Memorandum Department of Planning

Description: **Insituform, Lot 3 (17988 Edison)**: An Amended Architectural Elevation and Architect’s Statement of Design to renovate the main entrance of an existing office building on a 2.47-acre tract of land located at the southeast corner of Edison Avenue and South Goddard Avenue, zoned “M3” Planned Industrial District.

This letter is in response to your plan review comments regarding Institutform, Lot 3 (17988 Edison Ave) – 2024 AAE. The comments are numbered in correlation with your project.

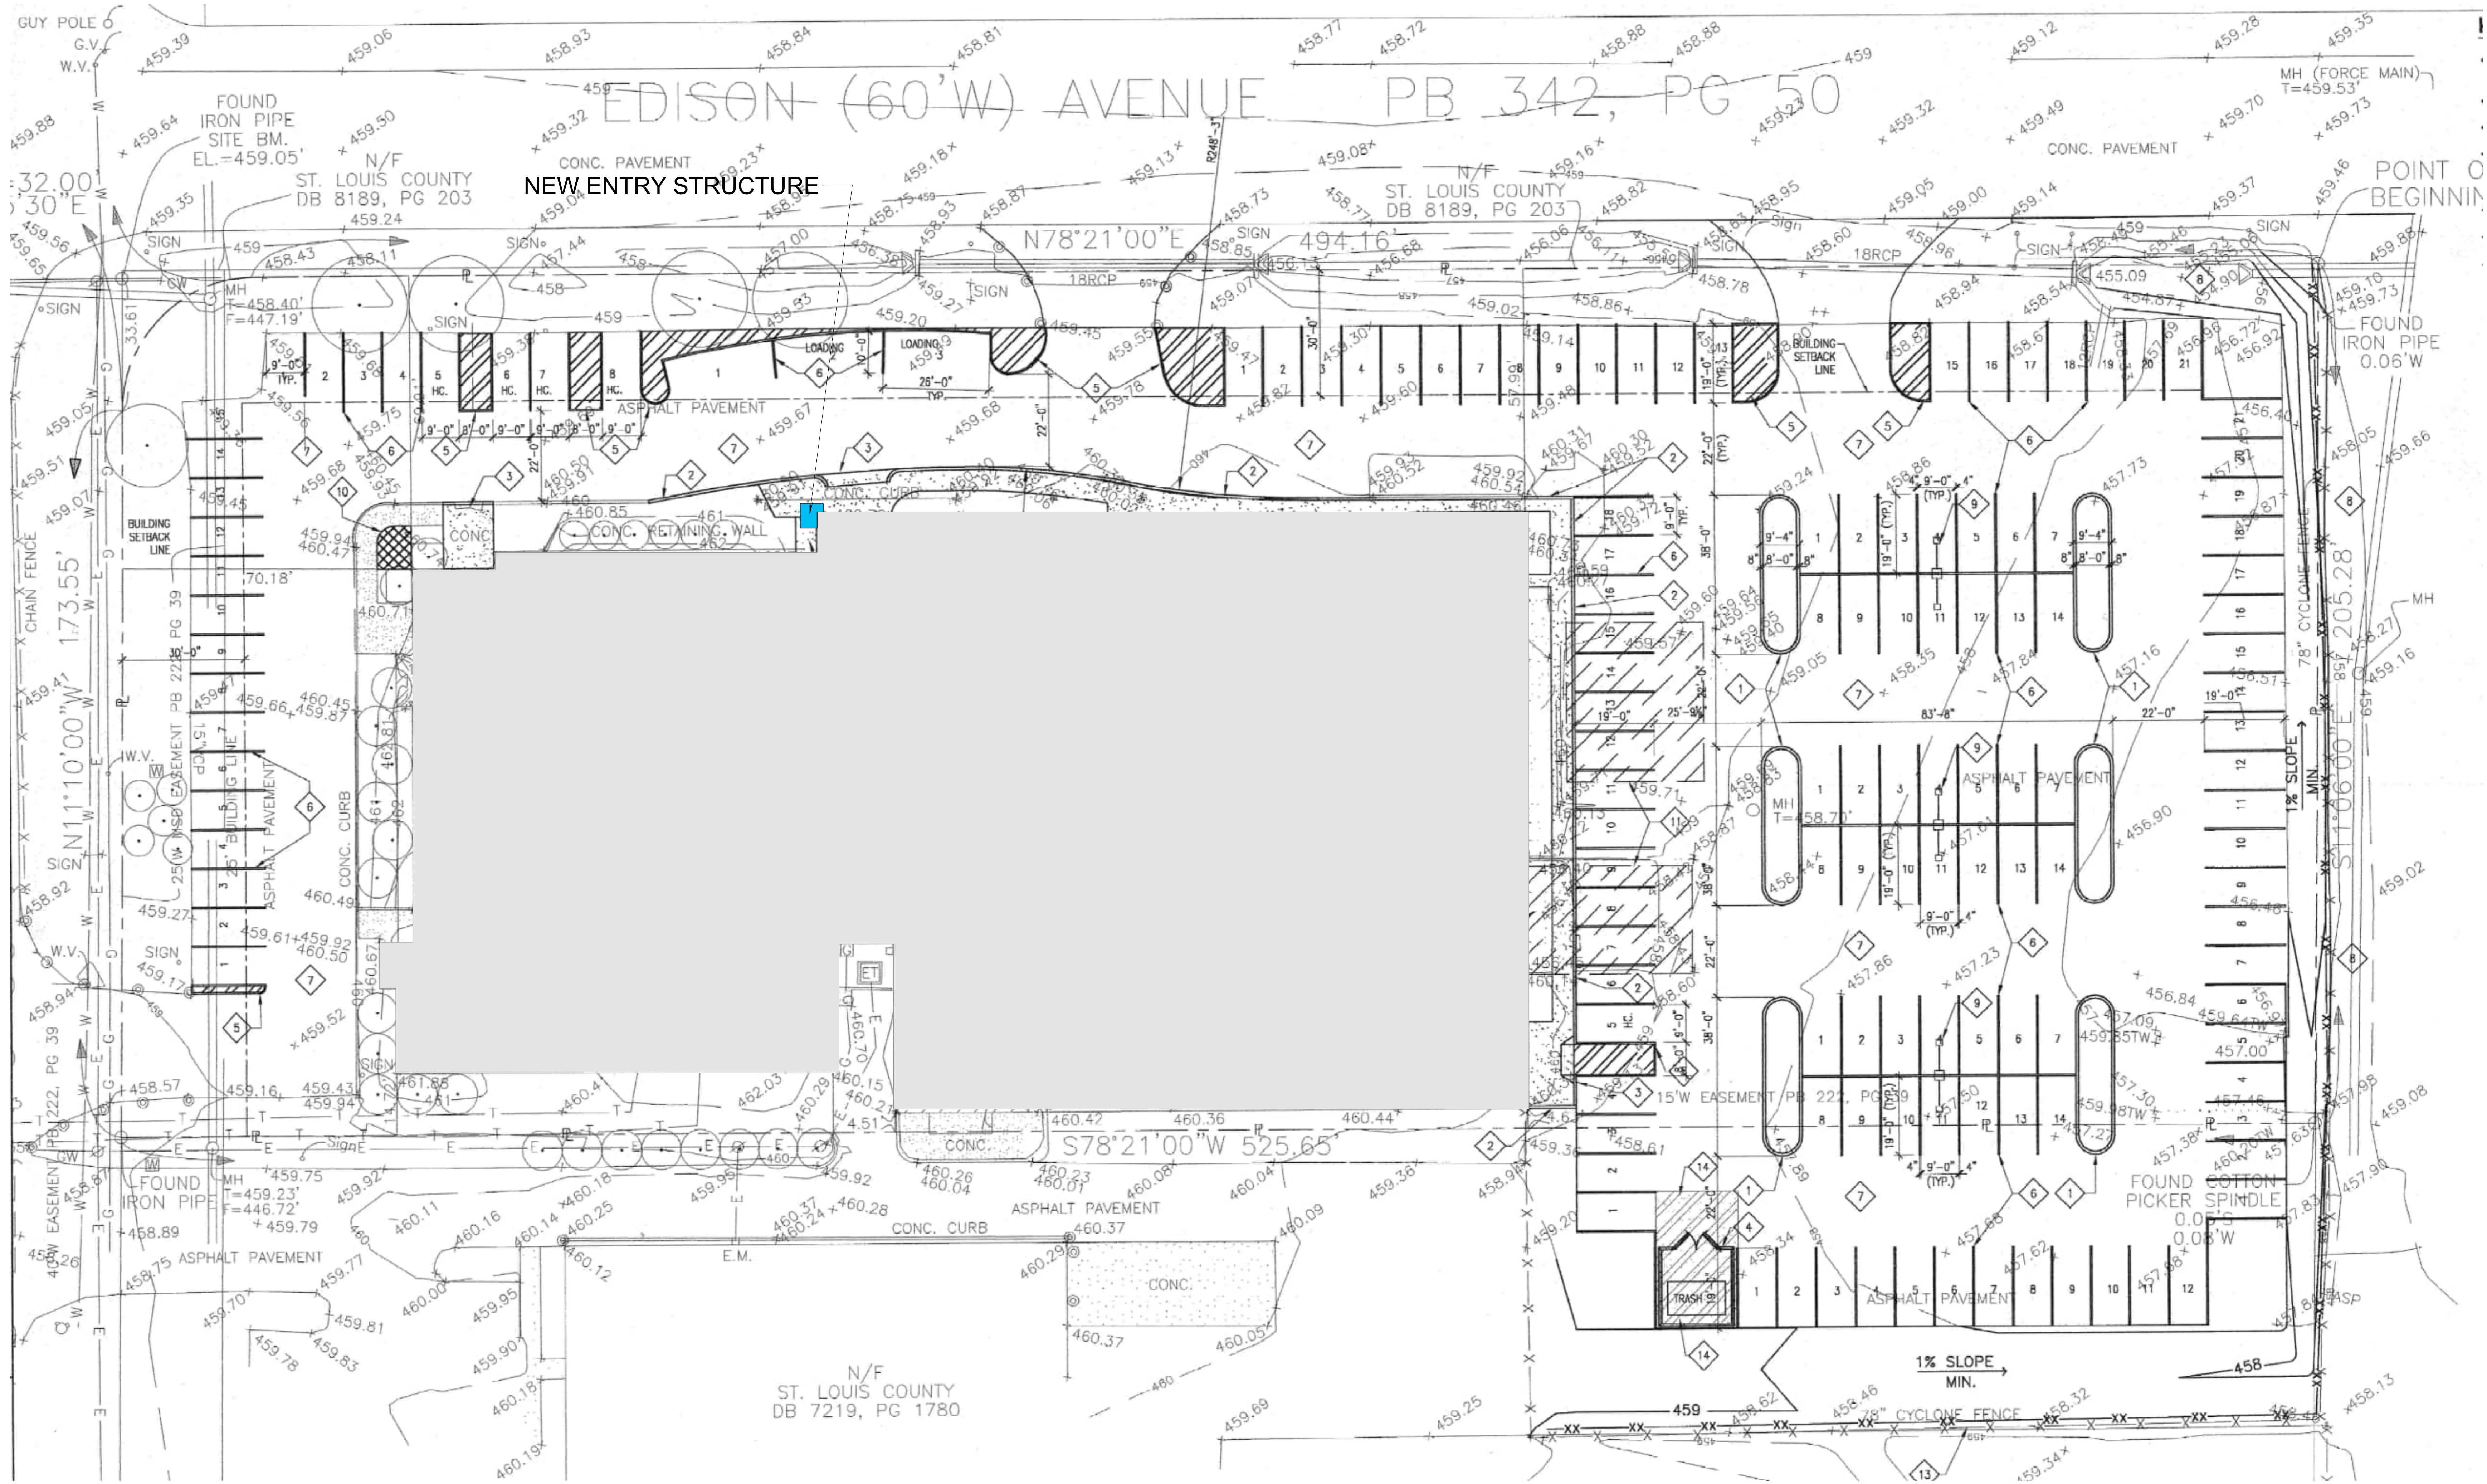
7. Signs and sign packages are reviewed through a separate process. Remove any signage from the elevations or rendering.

Response: All exterior signage has been removed from this design package.

1 NORTH ELEVATION
P-3 1/8" = 1'-0"

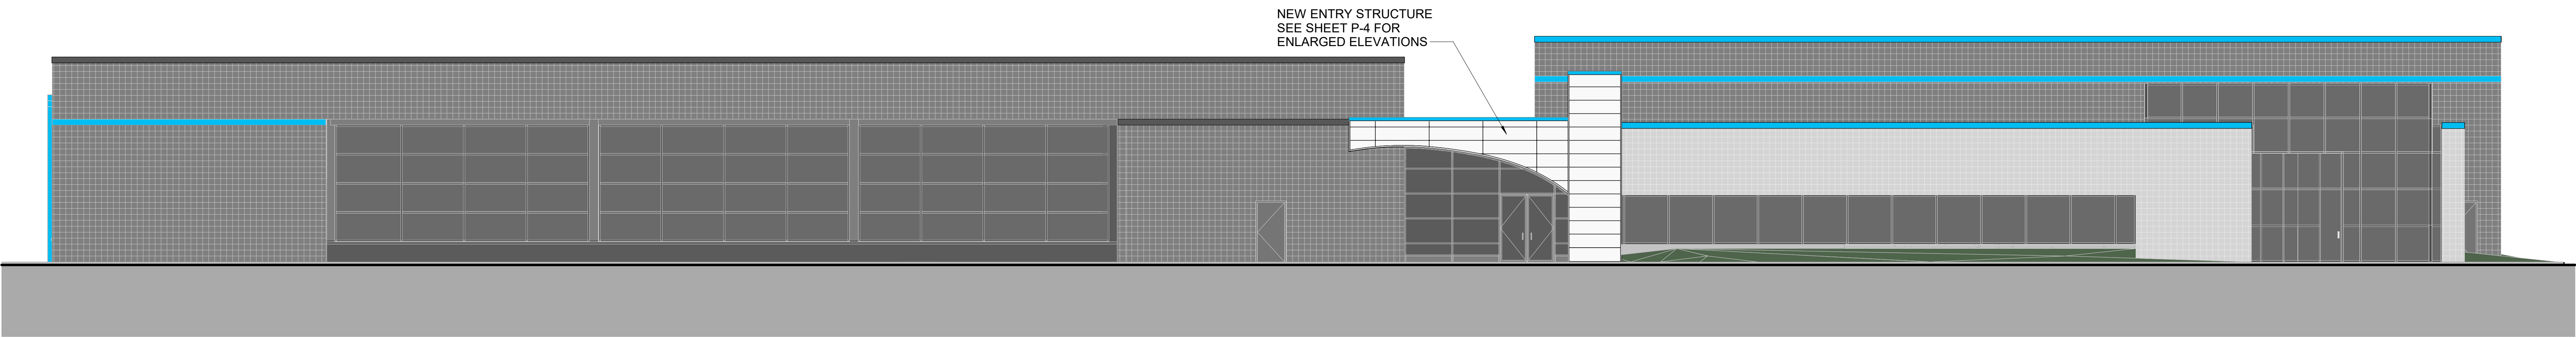
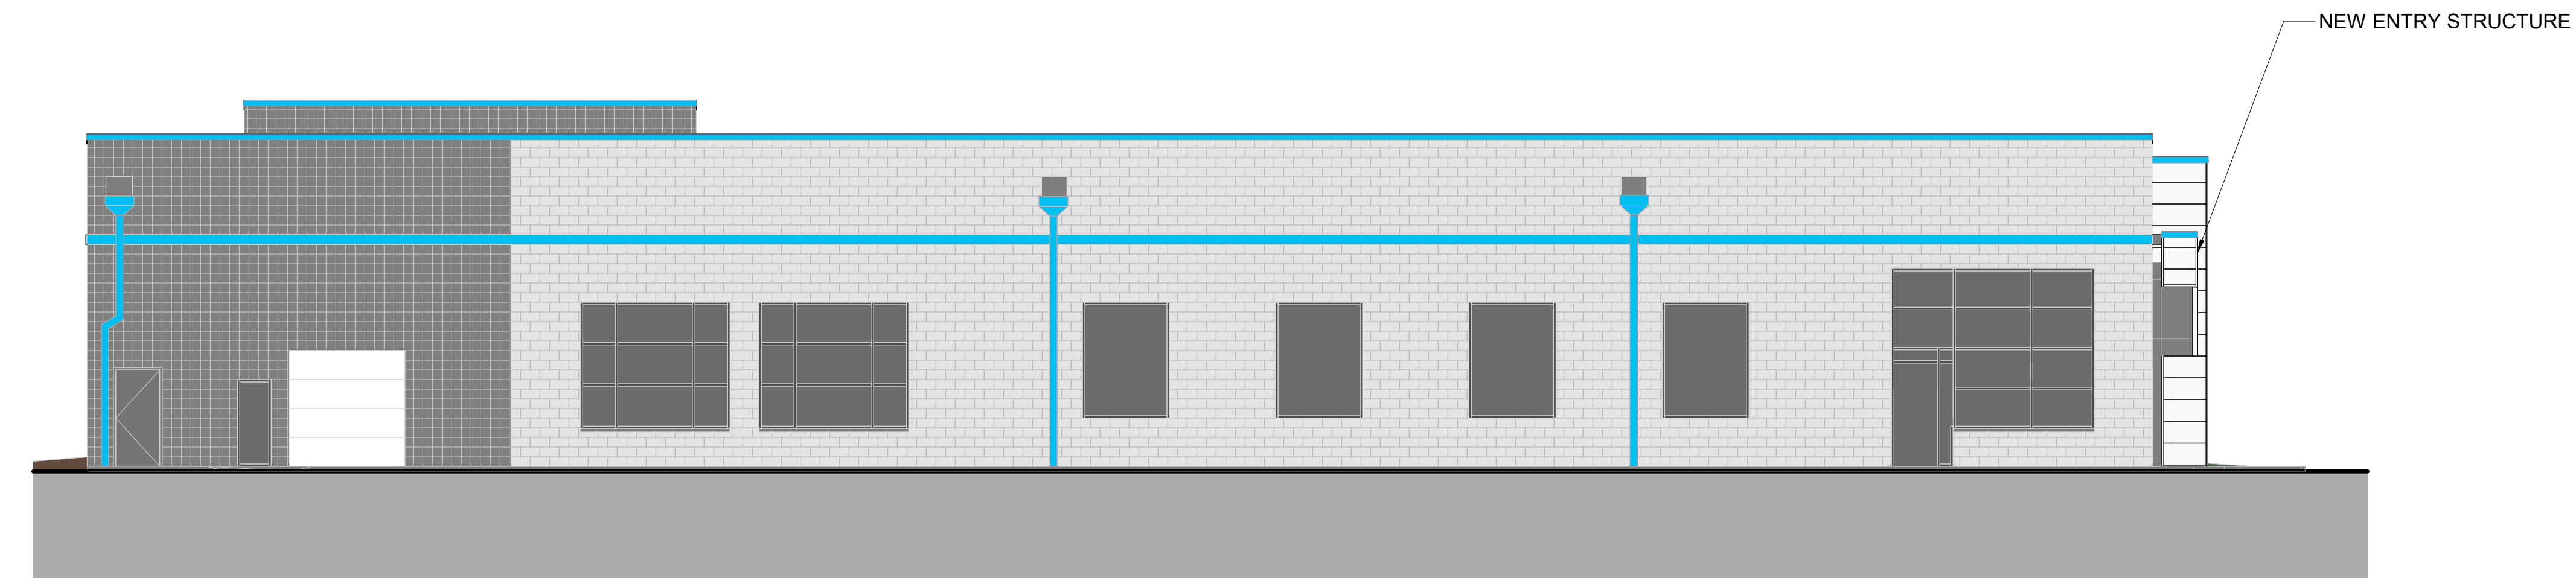
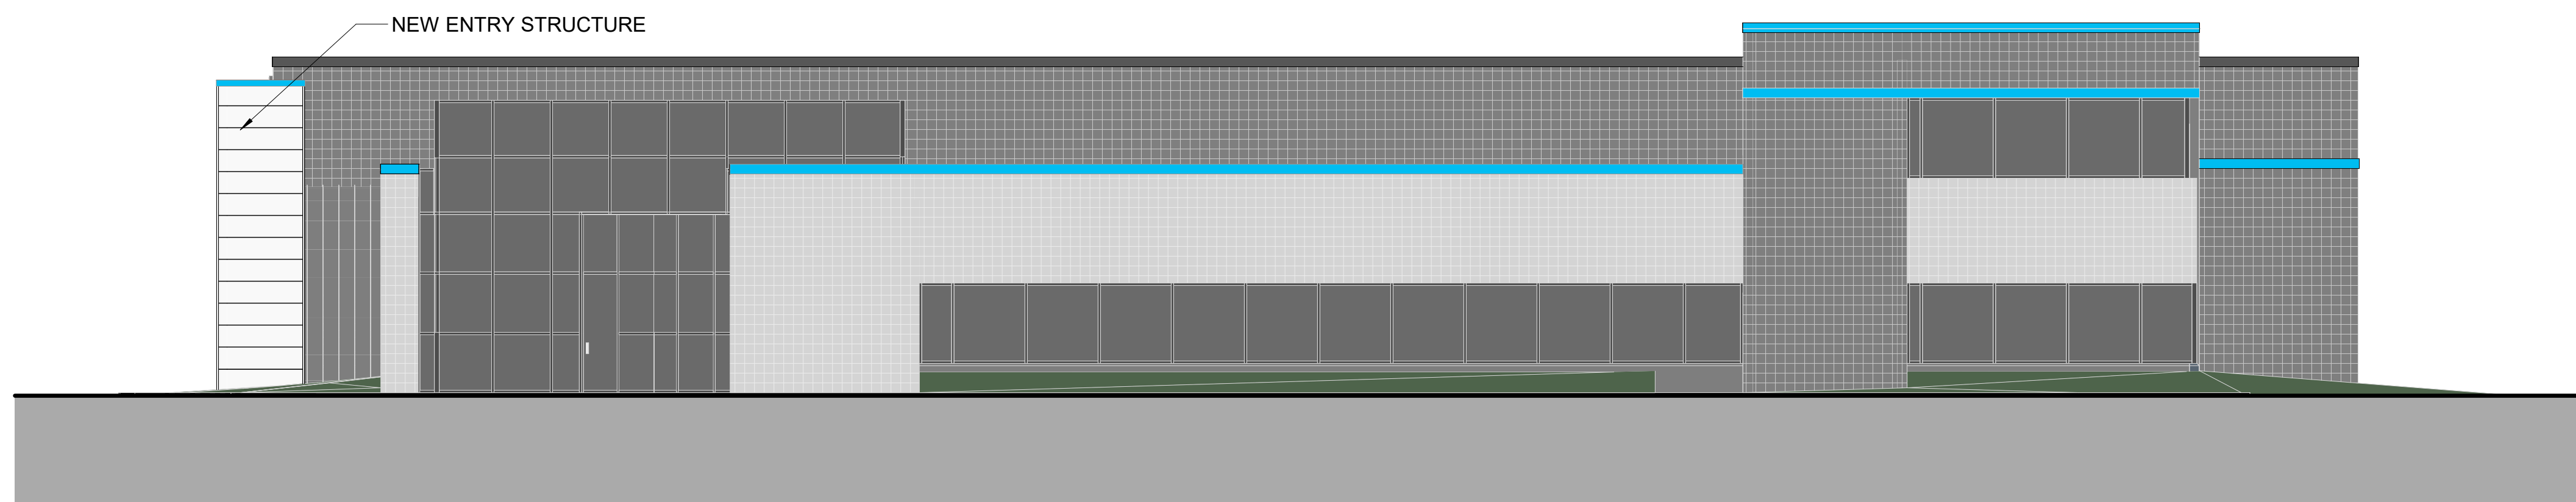
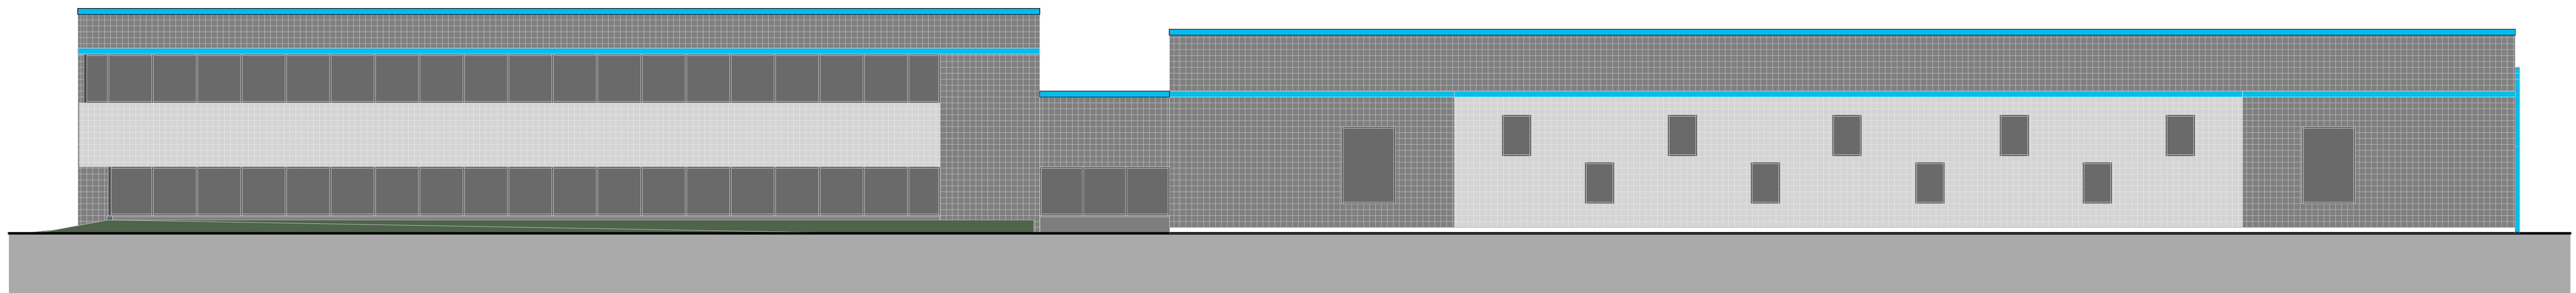
4. Provide entire color elevations for all building faces.

Response: Color elevations are included in this re-submittal
